—S. S. "N^o 258"—

Glasgow Report No. 6309.

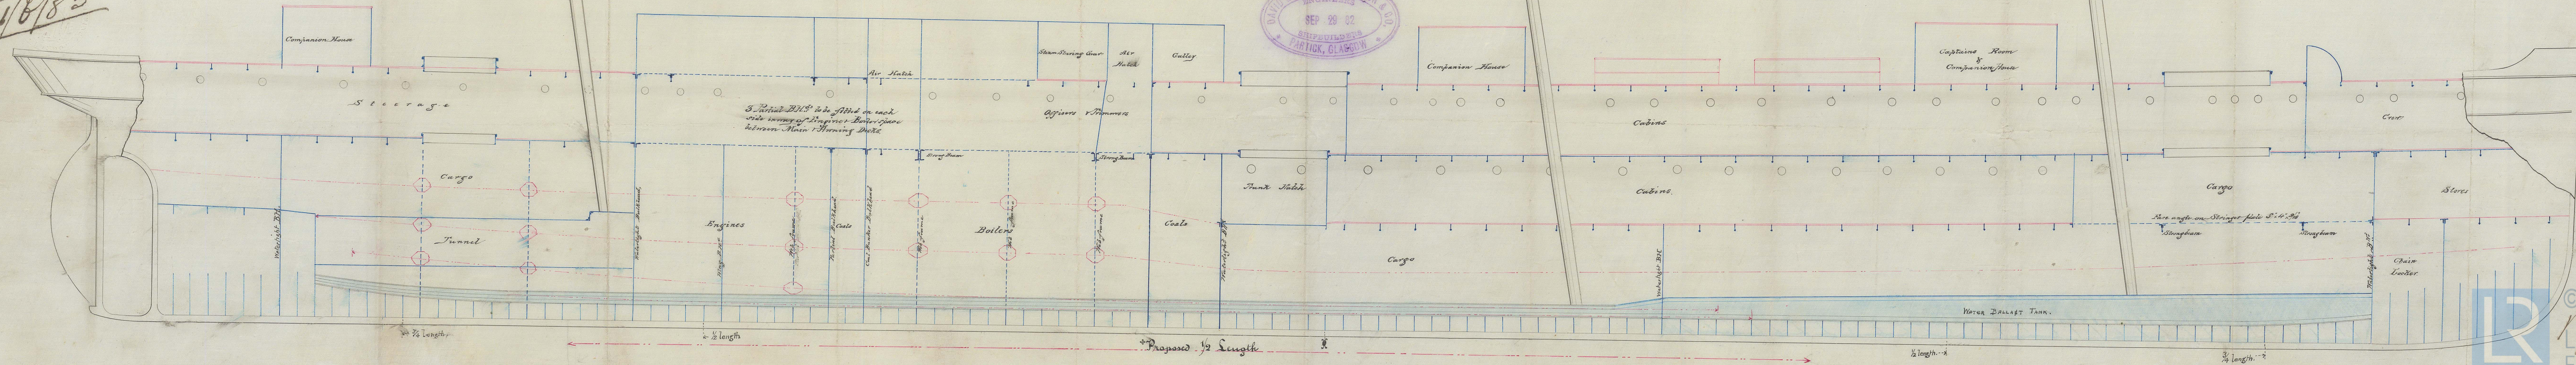
20.12.02 Side lights are only approximate & go between frames

³² It is possible the after Engine, B.H.^d may be shifted from 6 to 8 feet ^{from} of this, midship thickness of shell plating to be shifted forward in same relation to B.H.^e
